ARC REVIEW CODE: R2105201

TO: Mayor Keisha Lance Bottoms
ATTN TO: Monique Forte, Urban Planner III
FROM: Douglas R. Hooker, Executive Director
RE: Development of Regional Impact (DRI) Review

Name of Proposal: Englewood South DRI #3299

From: Auguin, Corentin <cauguin@itsmarta.com>
Sent: Thursday, June 3, 2021 1:56 PM
To: Greg Giuffrida
Subject: MARTA Comments Englewood South DRI
Attachments: Englewood South DRI Site Plan-MARTA Comments,4-14-21.pdf

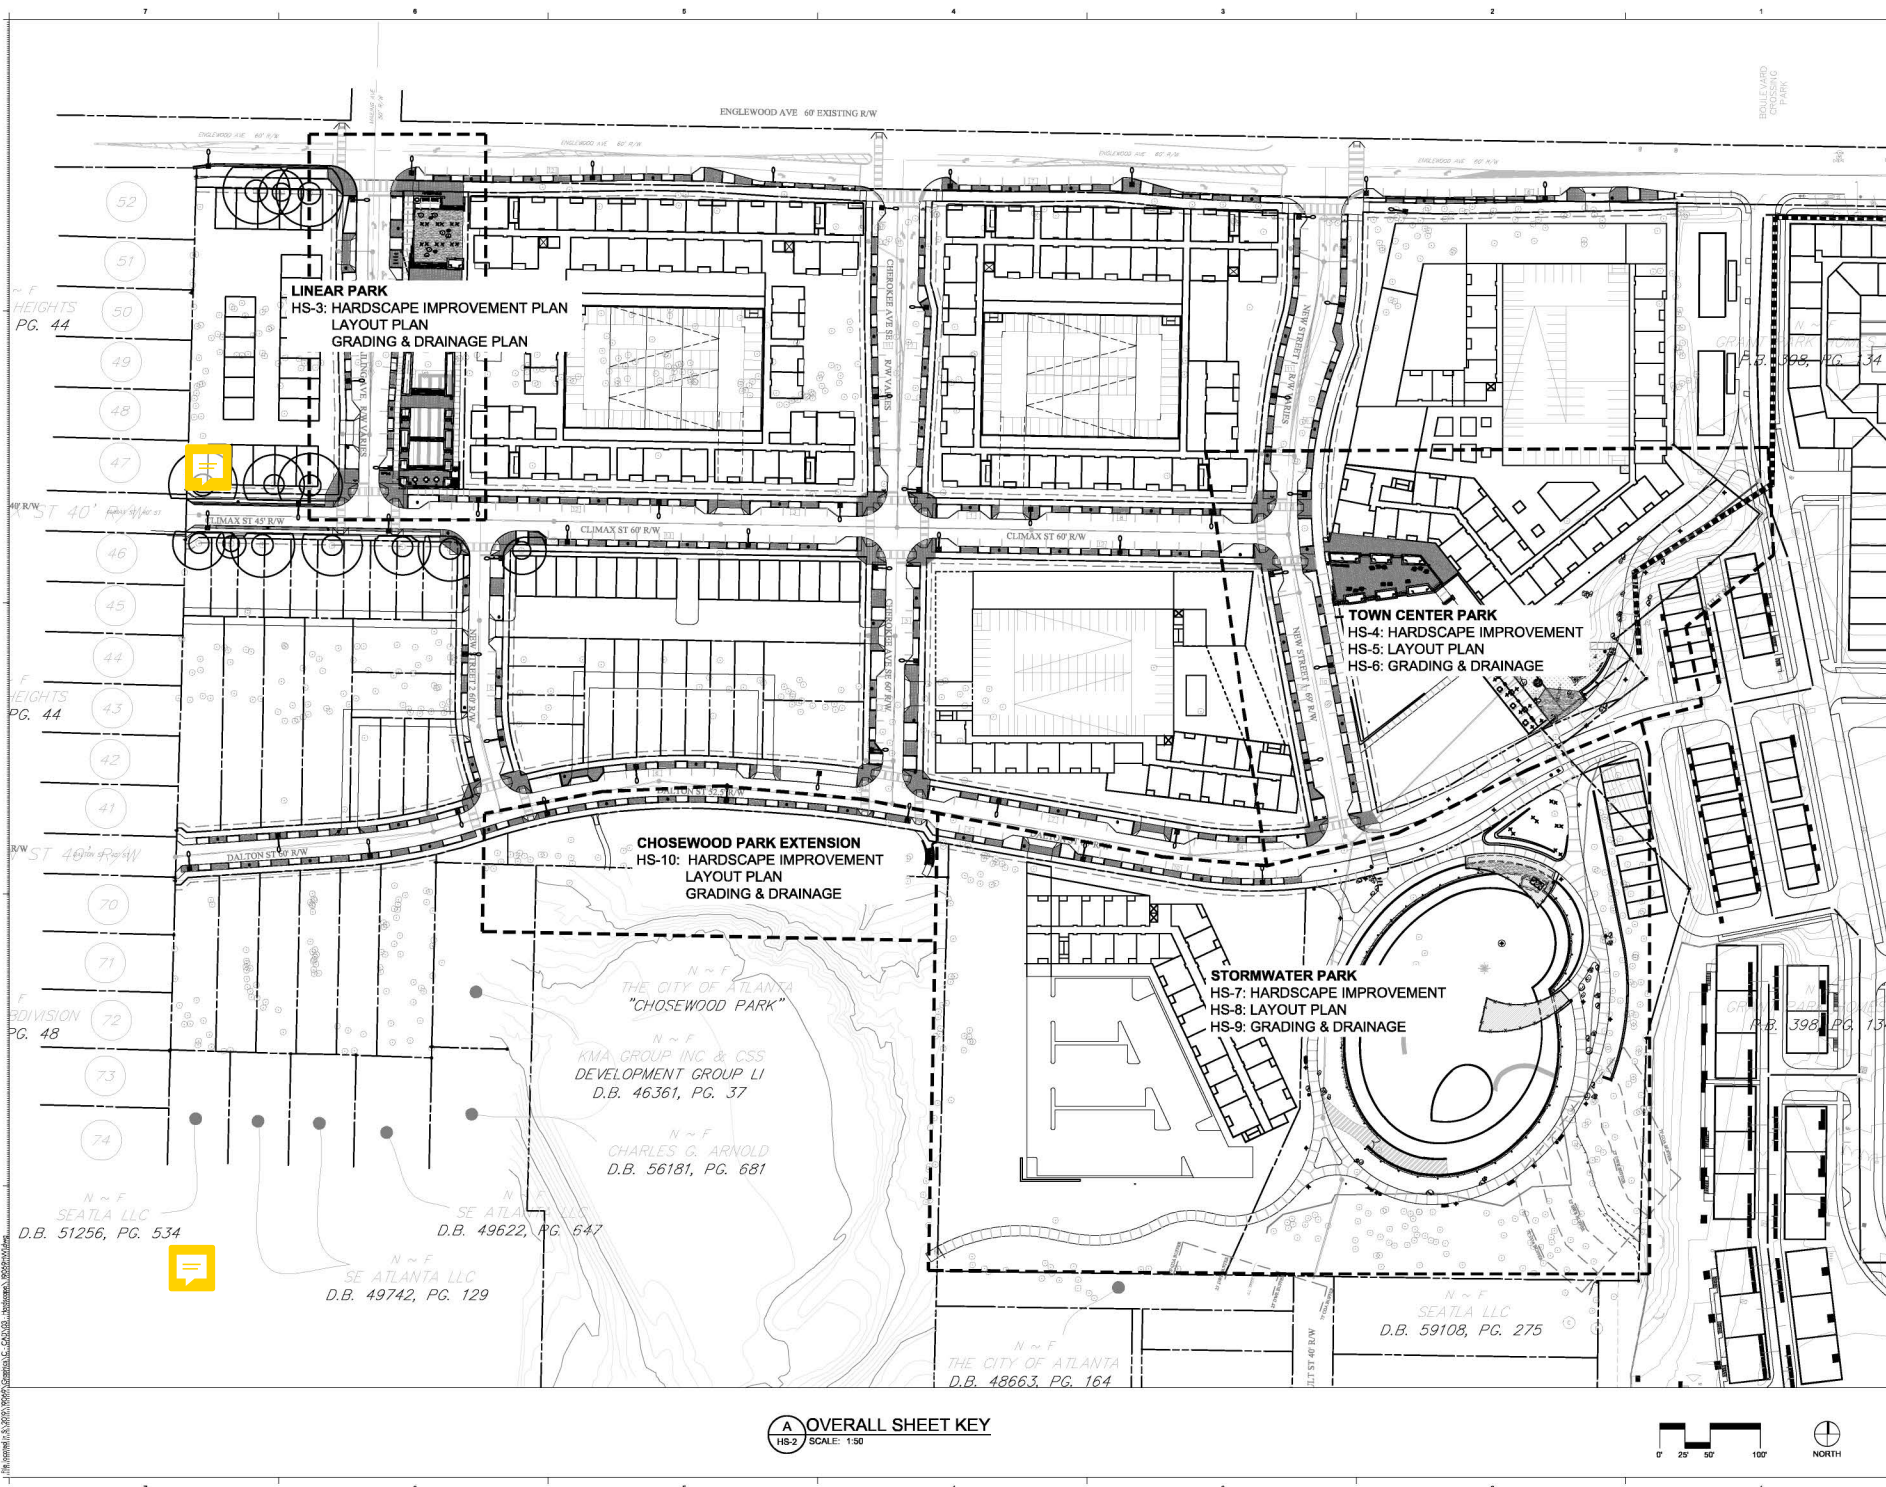
The main issue is the on-street parking blocking direct access to the curb. I suggest removing a few parking spots near Cherokee Ave for a 30 ft bulb-out to accommodate a bus stop serving the development.

We would also like to see a shelter pad in the vicinity of the proposed stop to accommodate a future shelter installation.

1021-TRAFFIC EXHIBIT
SHEET
CO-1

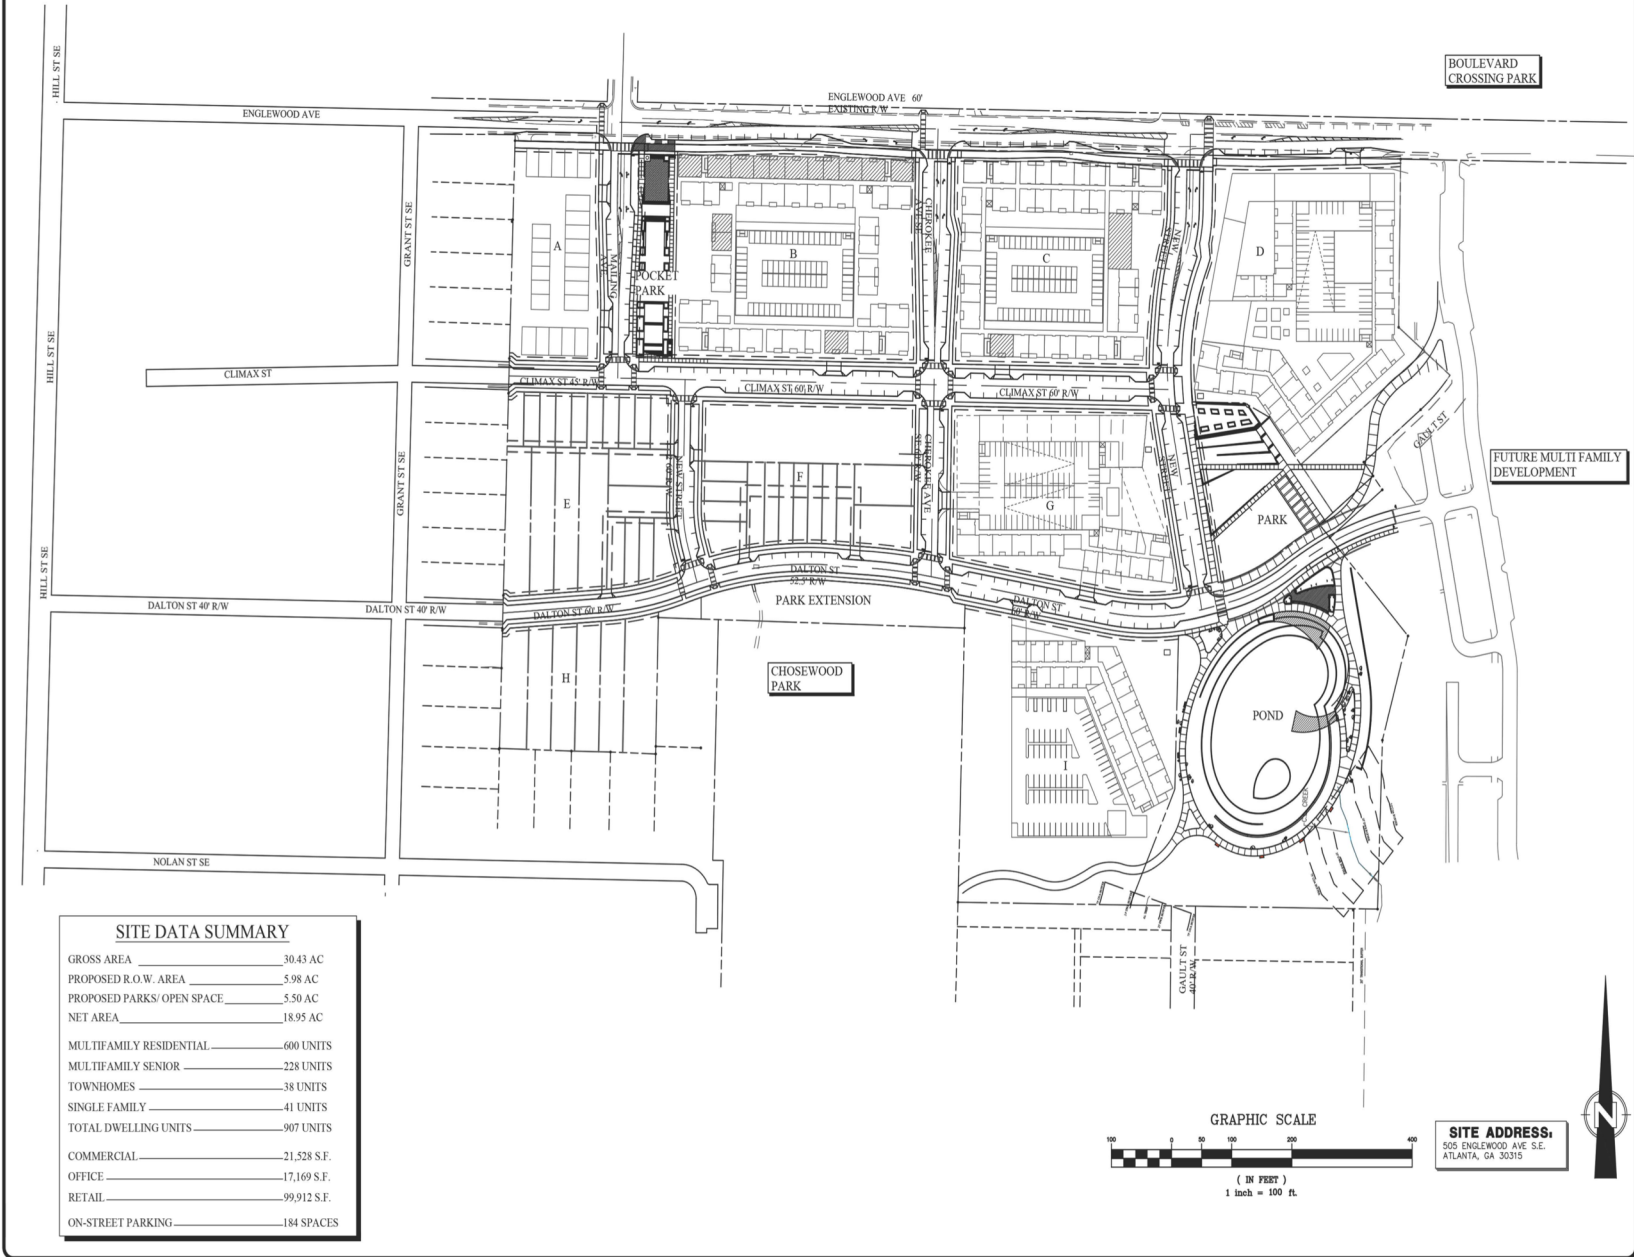
The USGS coverage for the project area shows no streams on or near the property. However, the submitted site plan shows a stream in the southeast corner of the property, running from the proposed stormwater detention pond to the southeastern edge of the property. The City of Atlanta 50-foot undisturbed buffer and 75-foot impervious setback, as well as the State 25-foot Erosion and Sediment Control Buffer are shown and identified. If the stream extends into the proposed detention pond, variances may be required. Any other unmapped streams on the property may also be subject to buffers required under the City of Atlanta Stream Buffer Ordinance. Any other unmapped streams or waters of the state on the property are also subject to the State 25-foot Erosion and Sediment Control Buffer.
